Our Ref: 23-1045
Your Ref: MCUC 2023_5563

RE: RESPONSE TO COUNCIL'S INFORMATION REQUEST ASSOCIATED WITH A MATERIAL CHANGE OF USE (DWELLING HOUSE) AT 12 MURPHY STREET PORT DOUGLAS.

**RFI CIVIL RESPONSE SUBMISSION
MCU - DWELLING HOUSES MCUC 2023_5563
12 MURPHY STREET, PORT DOUGLAS (L113 PTD2094)**

APPLIN — CONSULTING										M 0414 768 109 E greg@applinconsulting.com.au										KIM CULLEN & NEIL BIDDLE										PROJECT 12 MURPHY STREET RESIDENCE LOT 113 PTD2094 MURPHY STREET TITLE DRIVEWAY CL01 - CROSS SECTIONS										STATUS PRELIMINARY

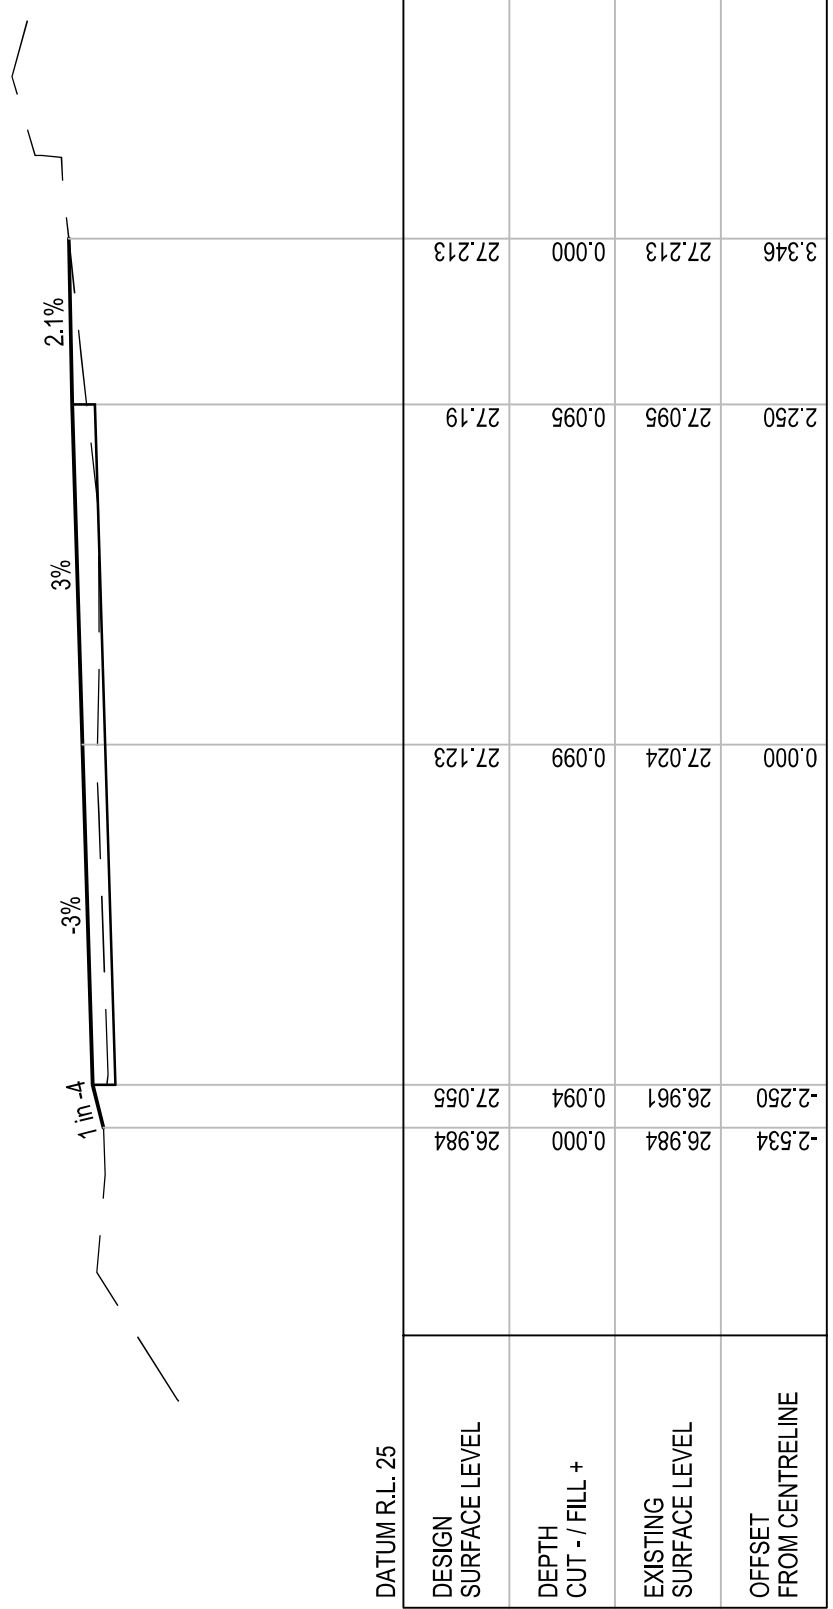
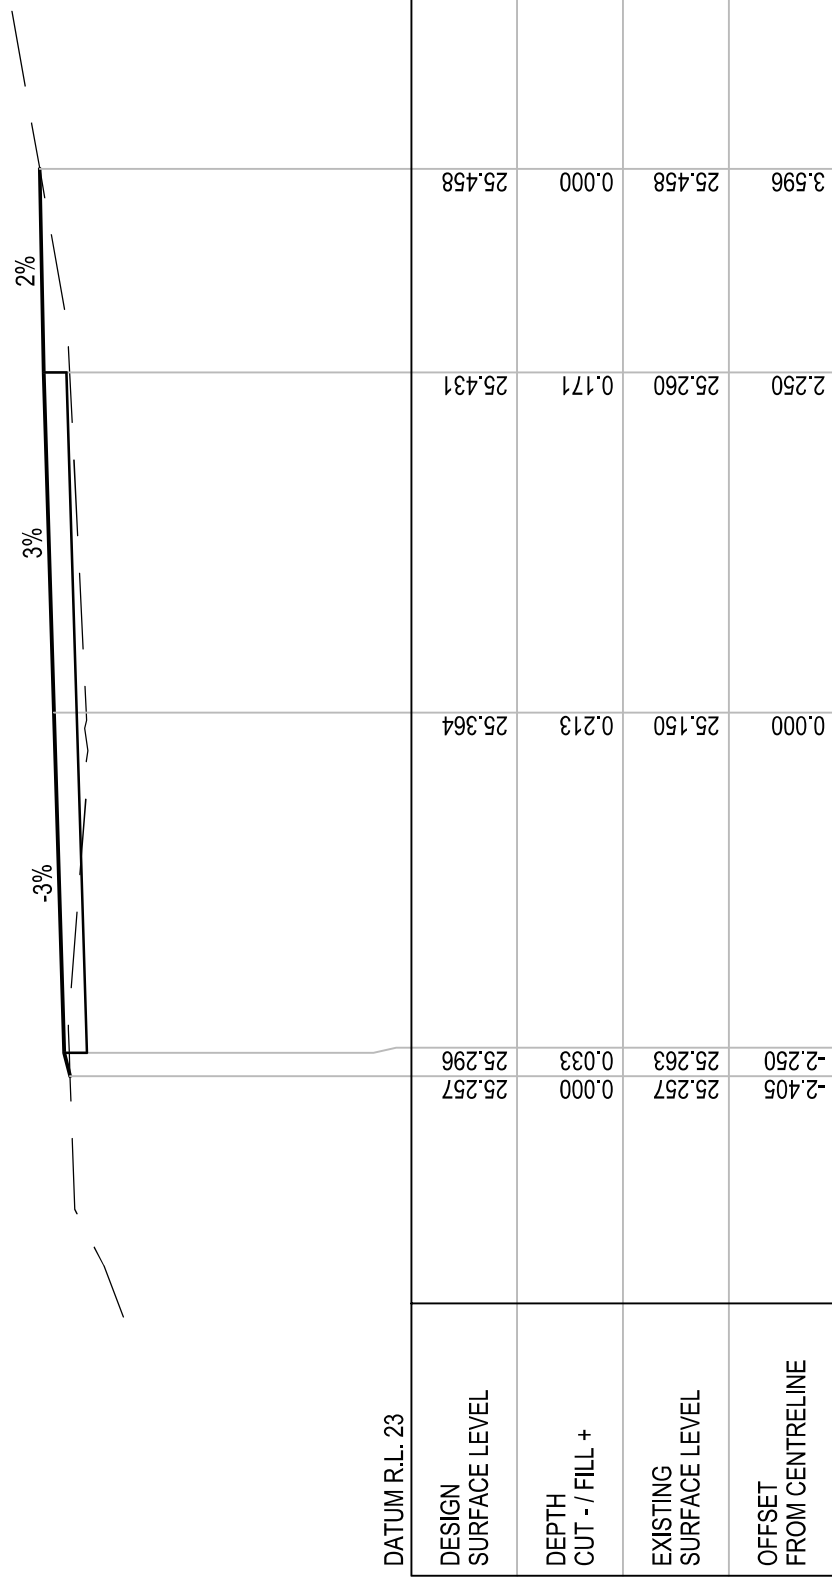
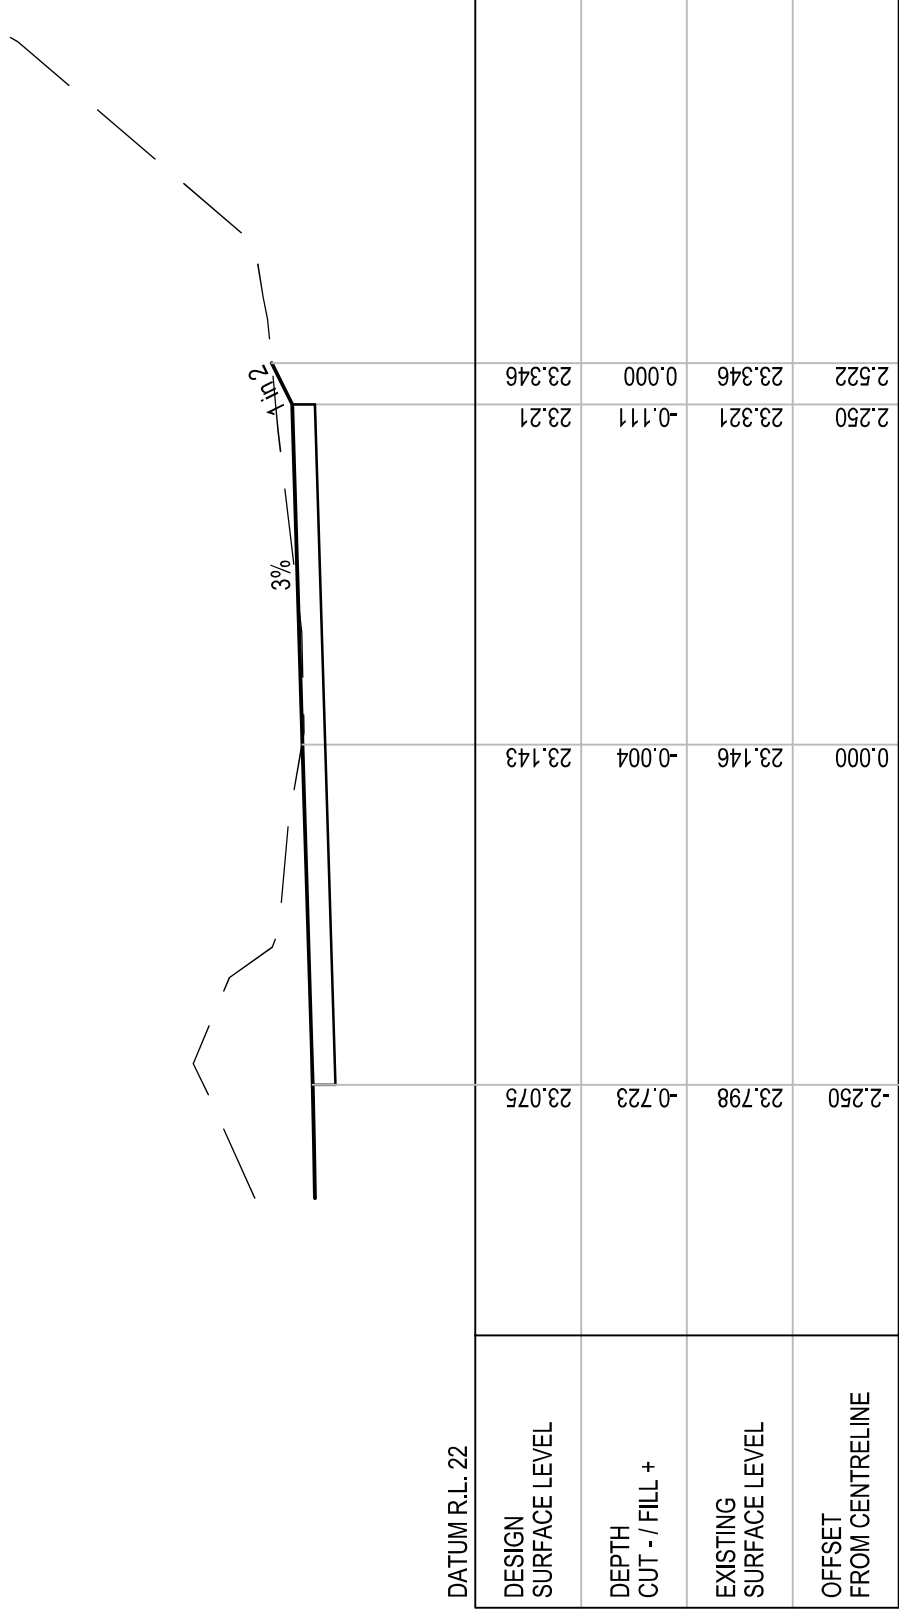
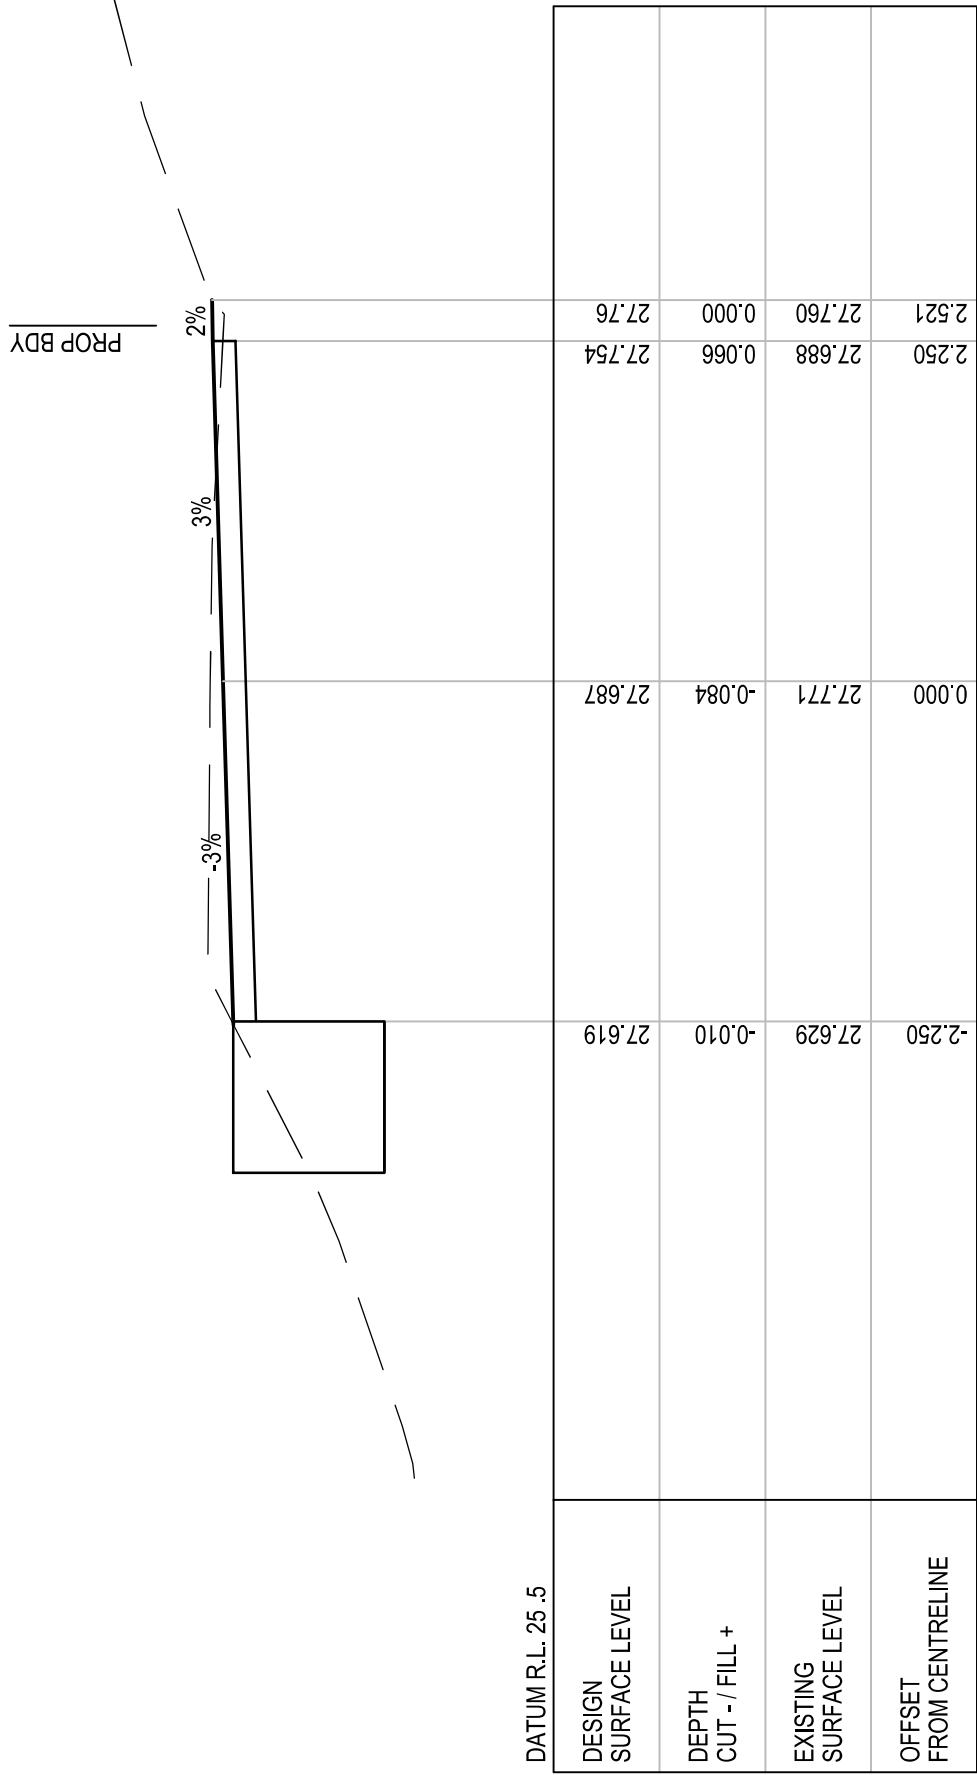
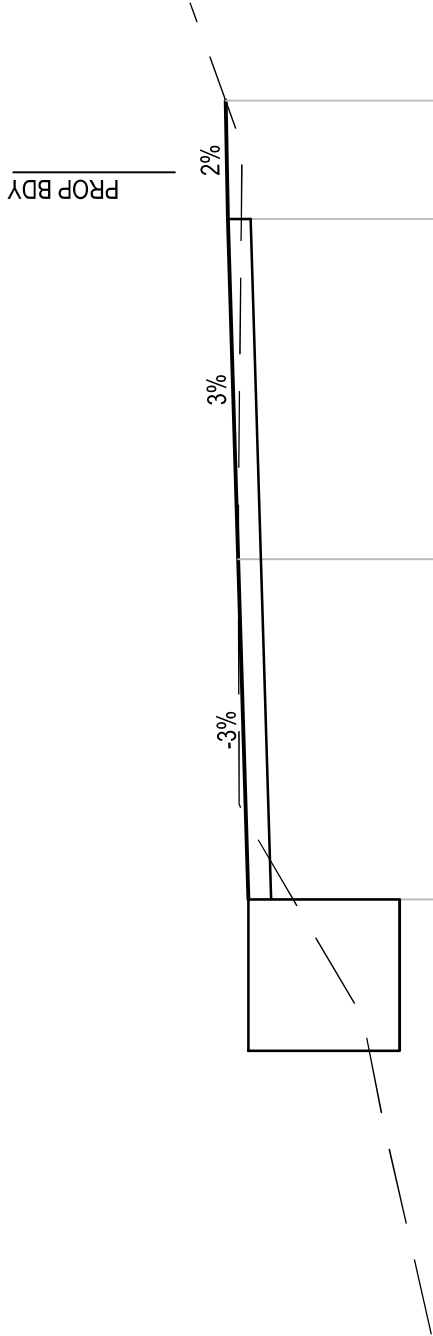
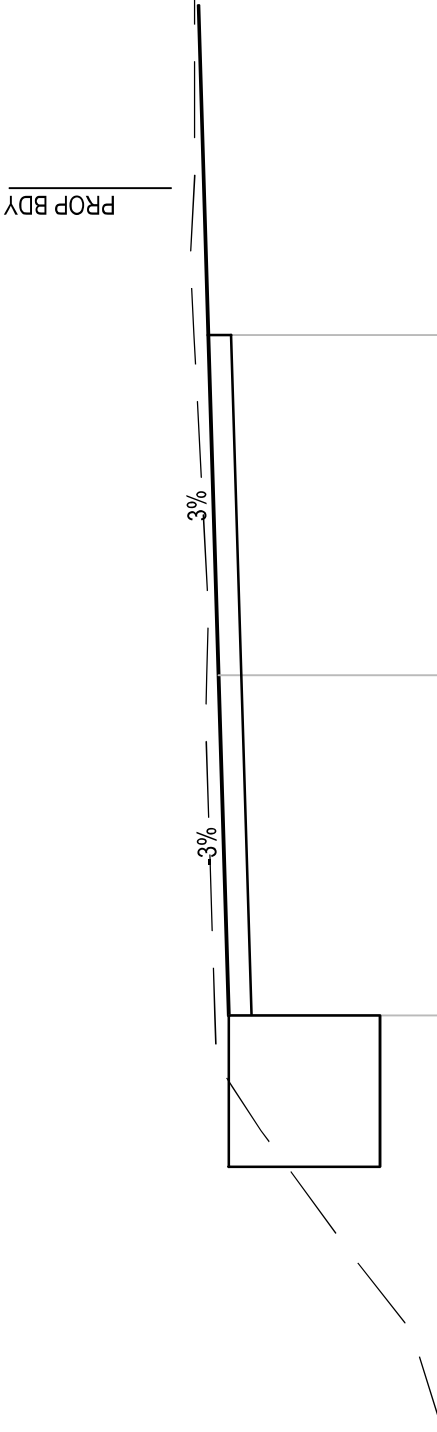
6. *Provide further information in the form of longitudinal and cross sections indicating the cut and fill required to construct the shared access in Murphy Street, and the internal driveway.*

Refer sketches provided in **Appendix B**.
